Addendum No.: 02

Date Of Addendum: April 12, 2021

DEEP West District Headquarters  
Black Rock State Park  
2065 Thomaston Rd, Watertown, CT  
BI – T – 615

The following clarifications are applicable to drawings and specifications for the project referenced above.

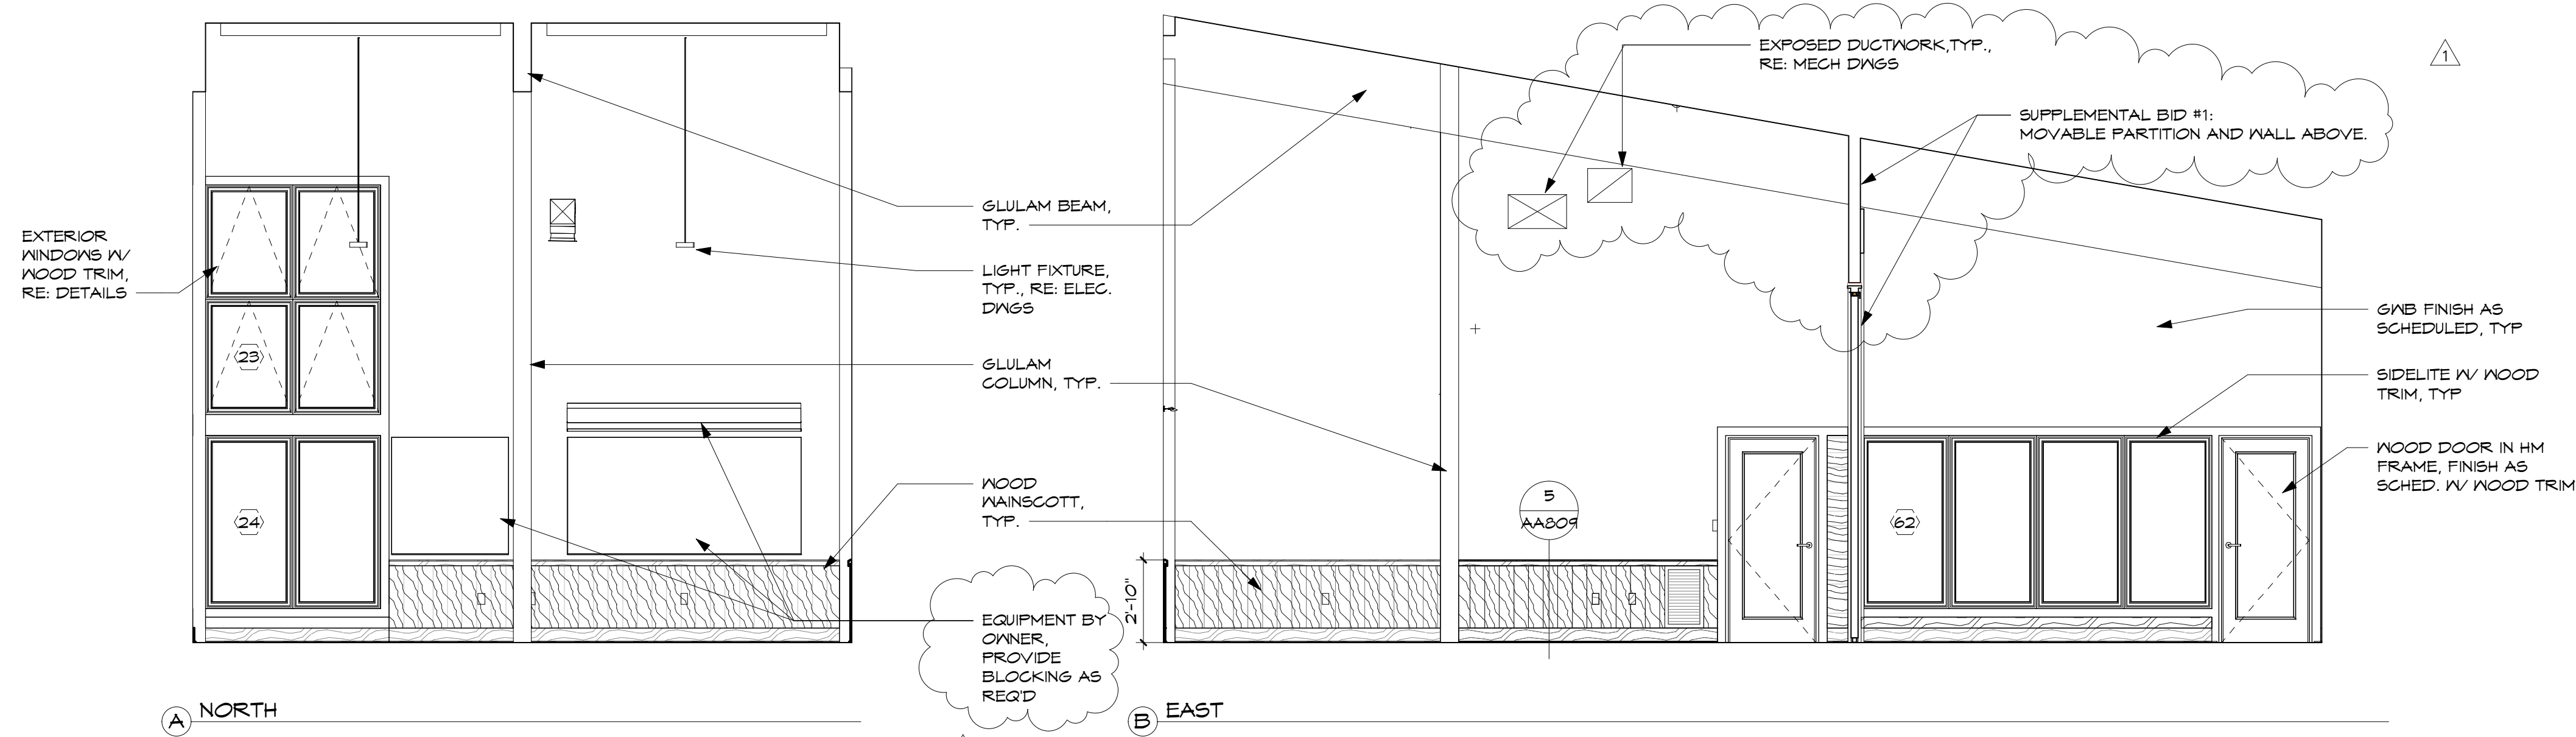
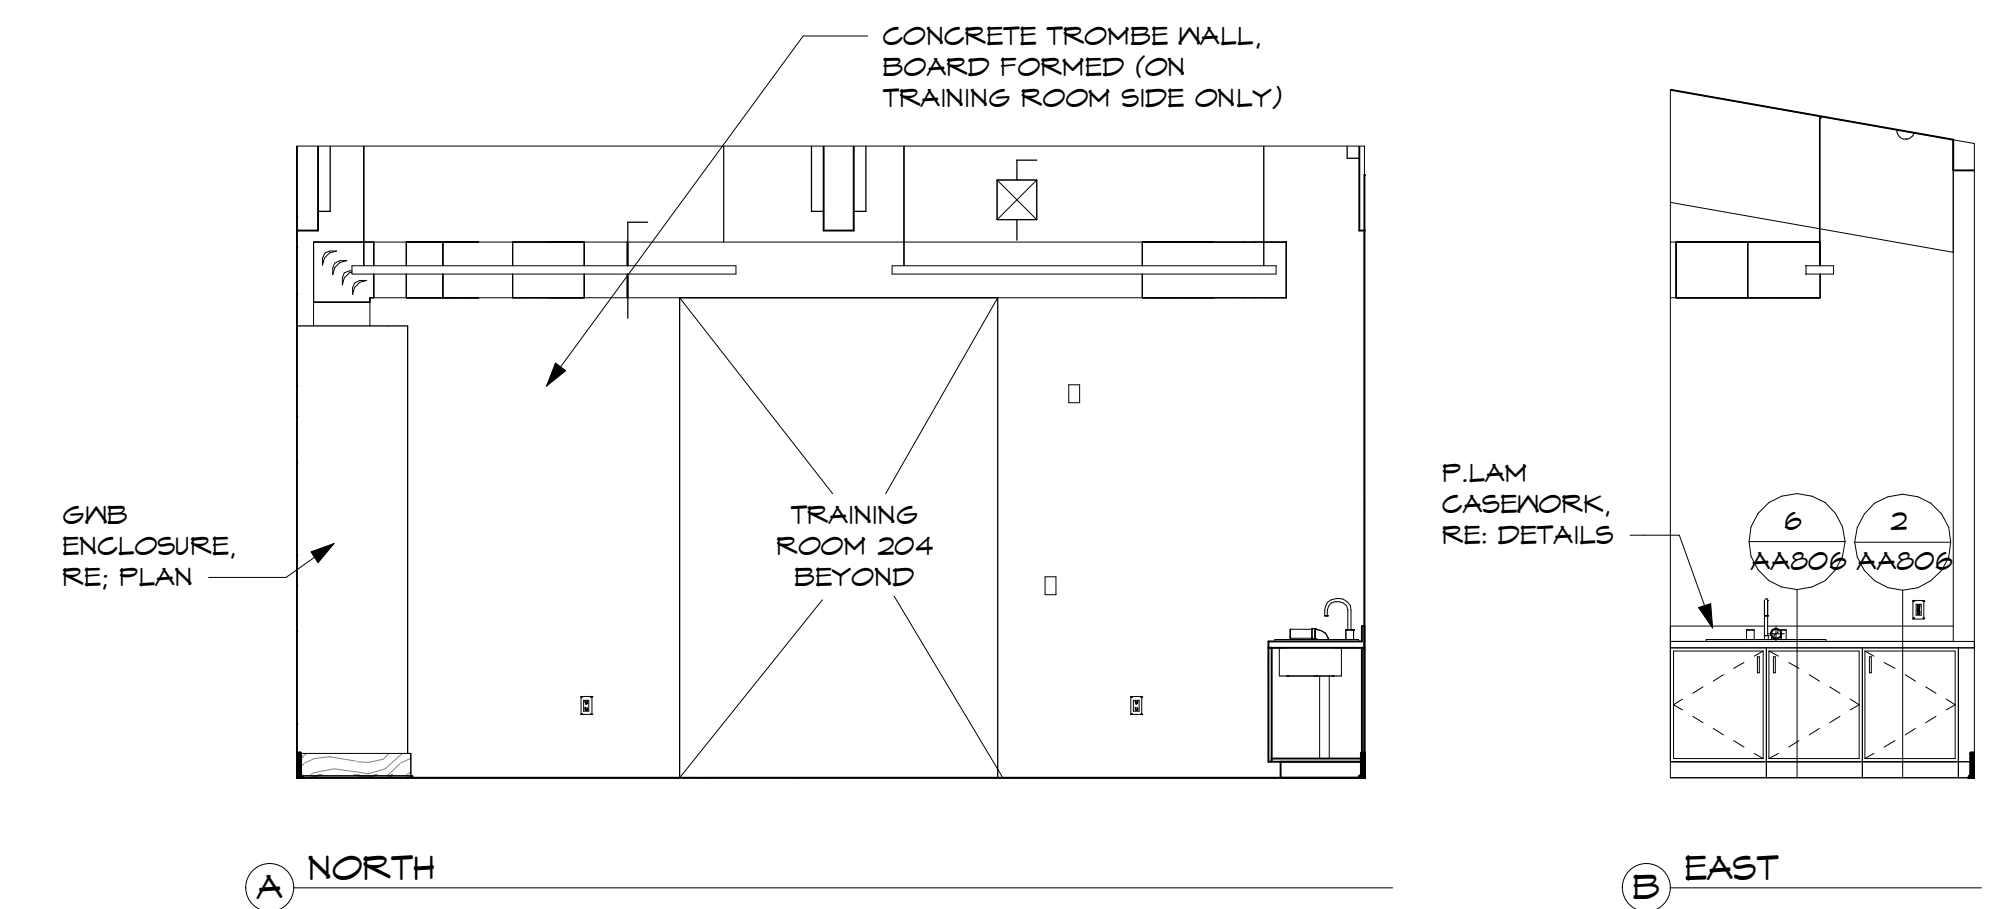
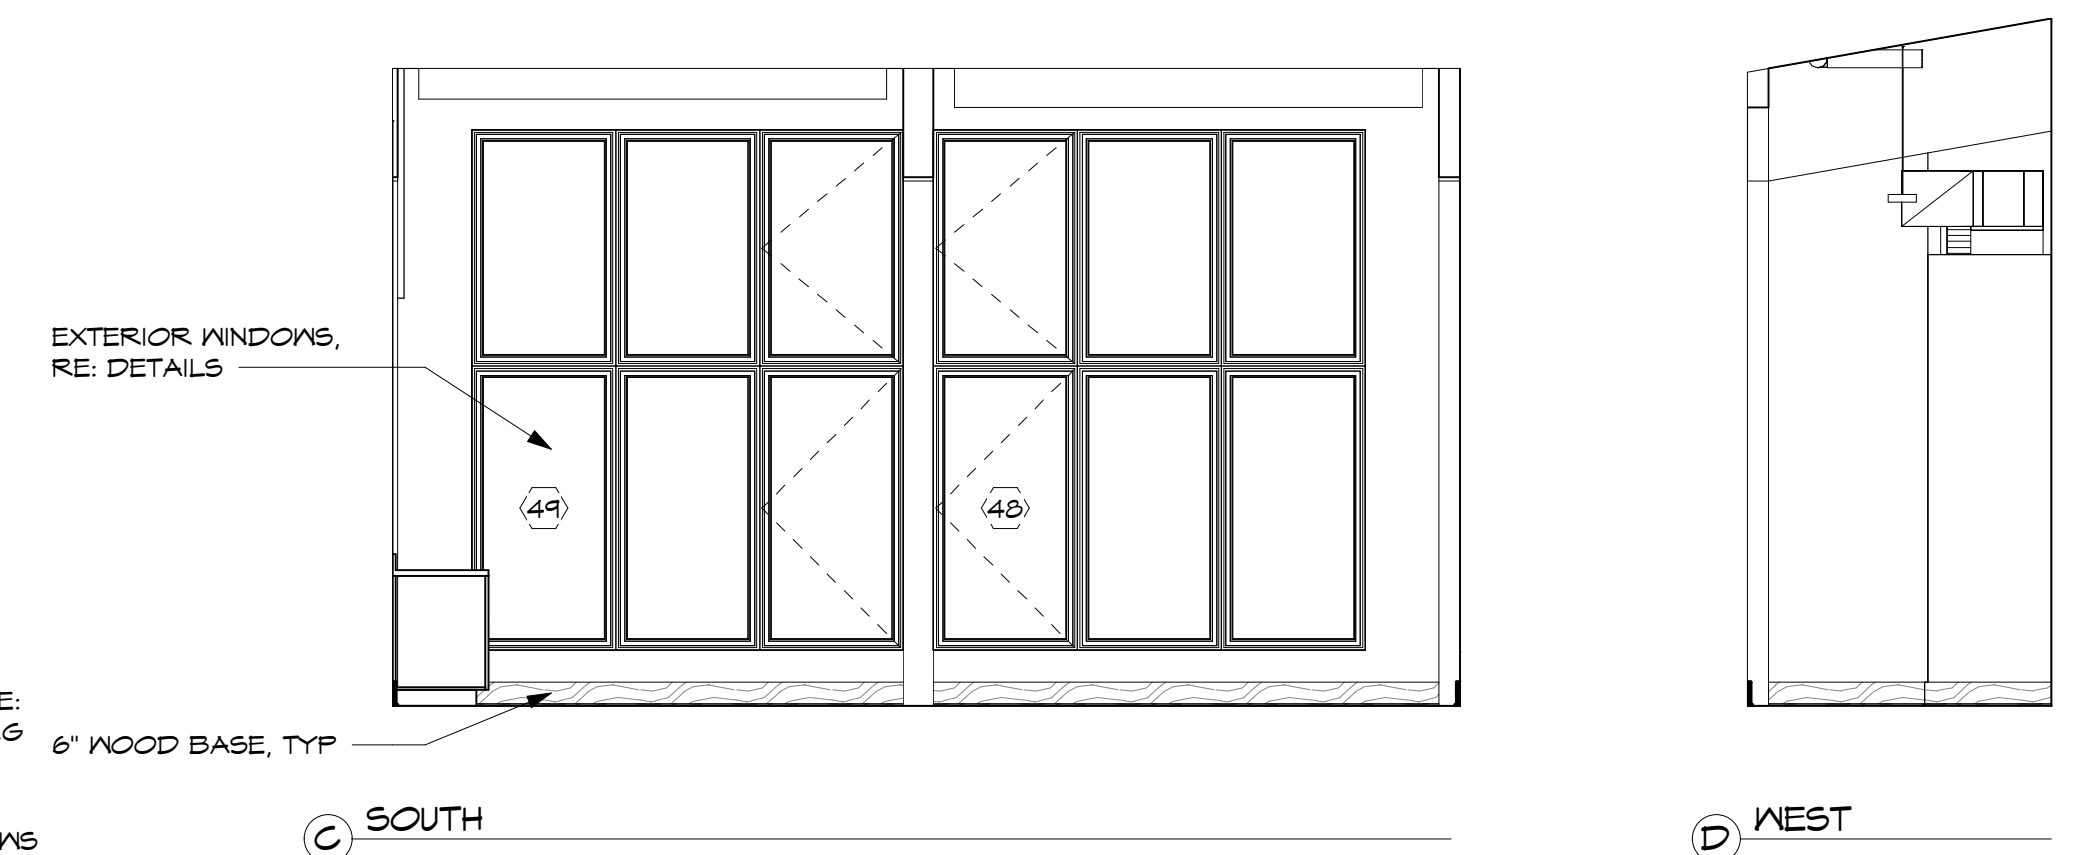
A. Drawing AA506 :

For Clarification: Additional call-out notes provided for drawing clarity. At Owner-provided equipment, provide blocking as required for mounting.
